Appl. No. 10/721,352 Responsive Amendment Dated January 4, 2007 Response to Office Action of November 24, 2006 Annotated Sheet I of 2

Request for Reconsideration:

FIG. 5

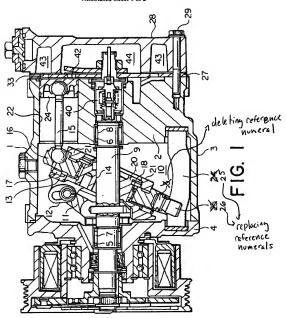
The drawings are objected to under 37 C.F.R. § 1.84(d) because reference numerals 26 and 36 allegedly are both used to designate the valve retainer. Fig. 4 is amended to designate the valve retainer with reference numeral 36. Further, Fig. 1 is amended to correct minor informalities in the drawings. The reference numeral designating the guide rod is changed from 24 to 25, the reference numeral designating the clamping portion is changed from 25 to 26, and an extra reference numeral 3 is deleted. Thus, Applicants respectfully request that the Examiner withdraw the objection to the drawings.
